November 1, 1982
SBN- 349
T.F. B7.i.2

References: (a) Construction Permits CPPR-135 and CPPR-136, Docket
Nos. 50-443 and 50-444

Subject: Revision to FSAR Figure 13.1-5 (Seabrook Station Organization)

PUBLIC SERVICE COMPANY OF NEW HAMPSHIRE
 FINAL SAFETY ANALYSIS REPORT
 SEABROOK STATION - UNITS 1 & 2
 SEABROOK STATION ORGANIZATION
 FIGURE 111.3

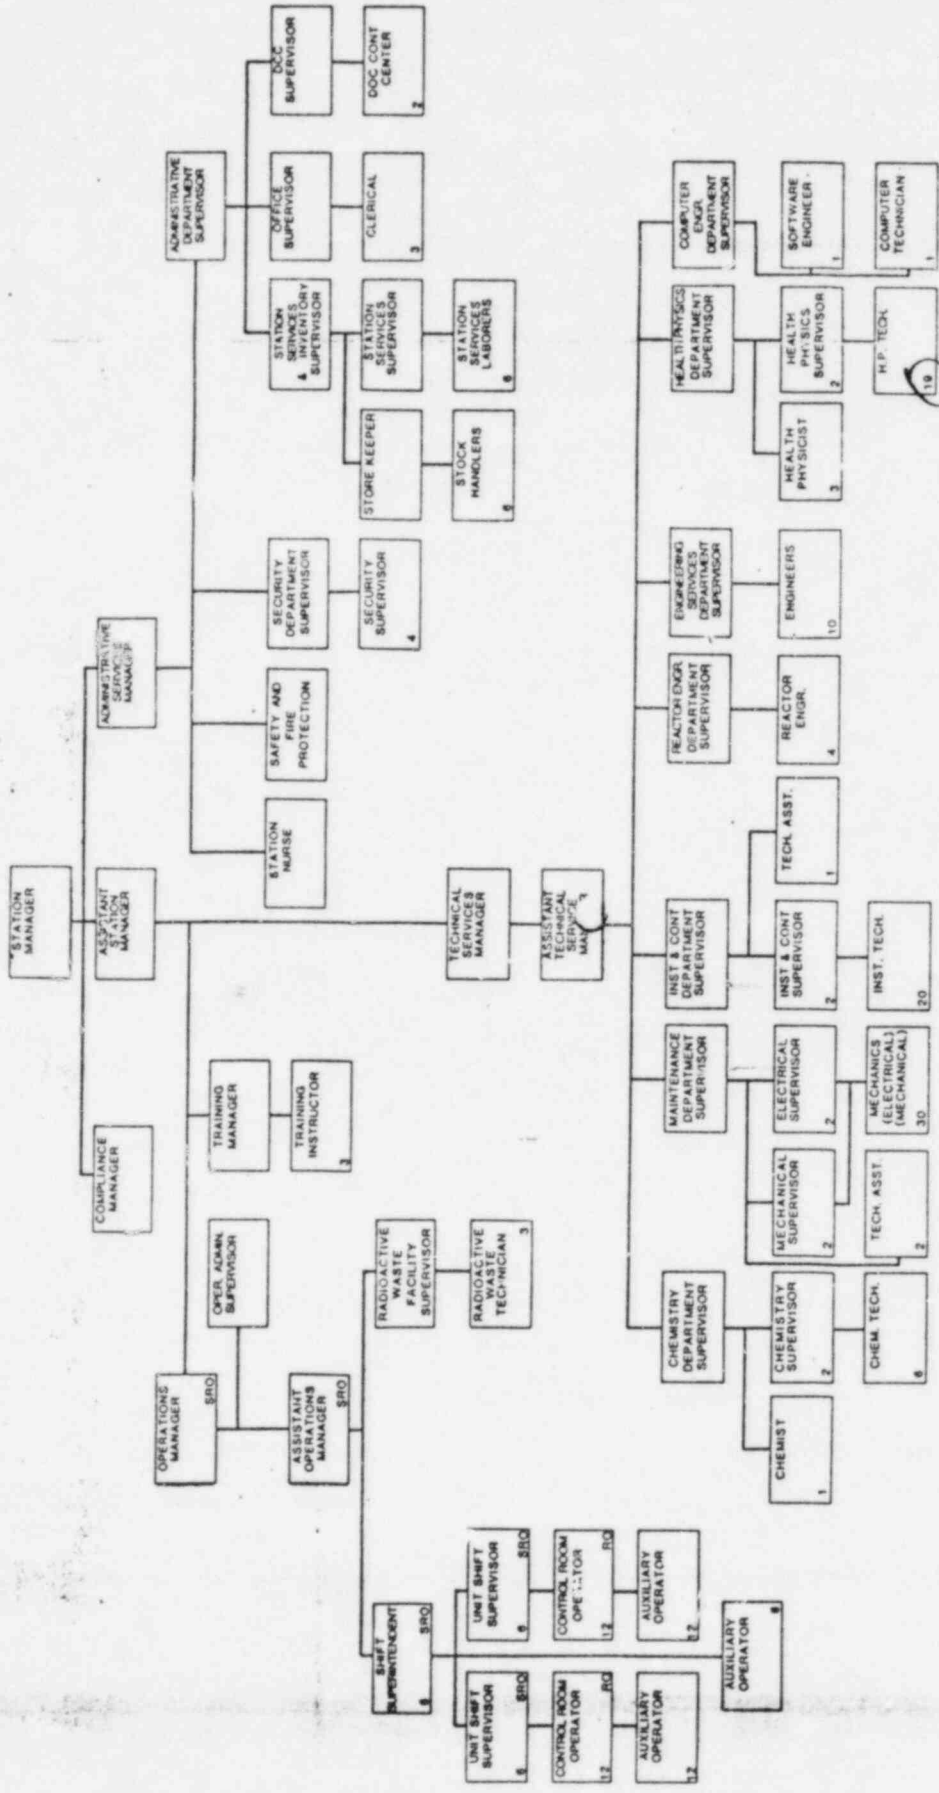
Figure 13.1-5 has been revised to reflect an increase in the number of Health Physics Technicians.
